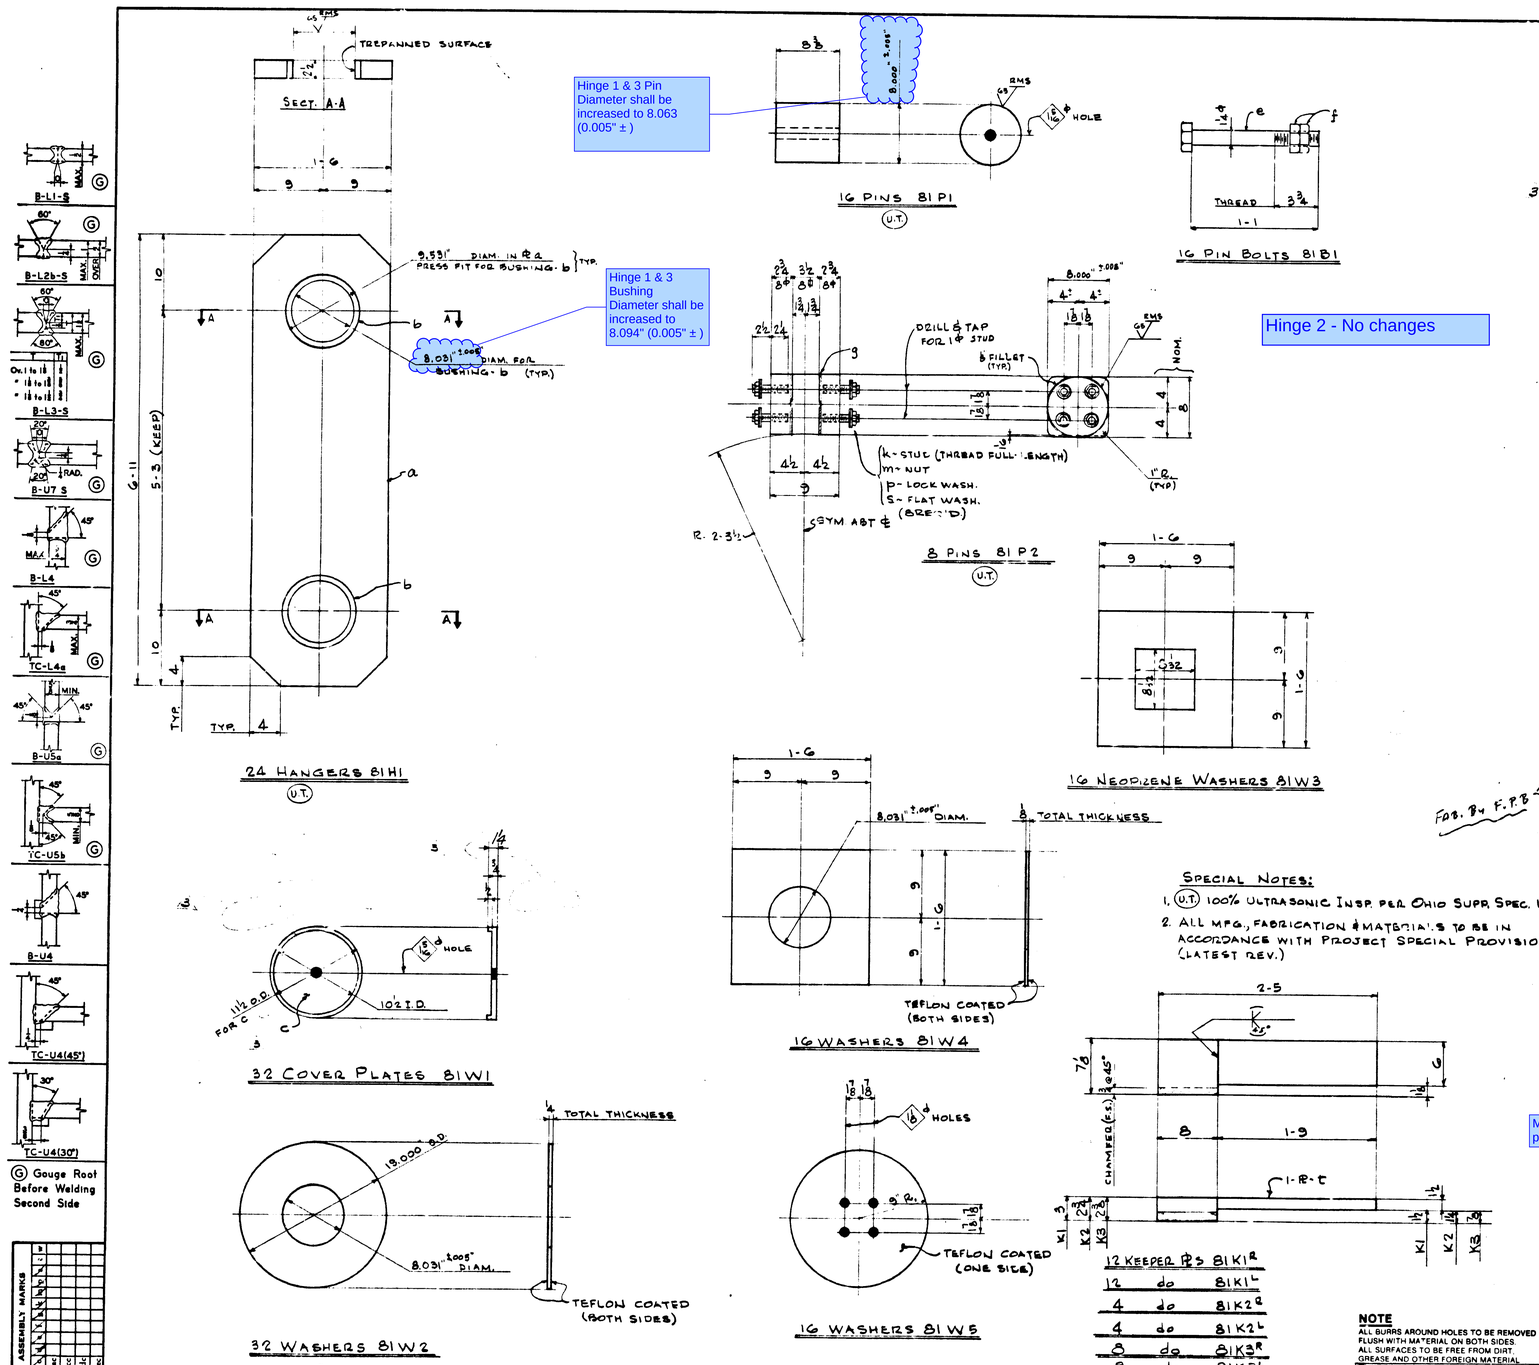
Hinge 1 & 3 Pin Diameter shall be increased to 8.063 (0.005" ±)

Hinge 1 & 3 Bushing Diameter shall be increased to 8.094" (0.005" ±)

Hinge 2 - No changes
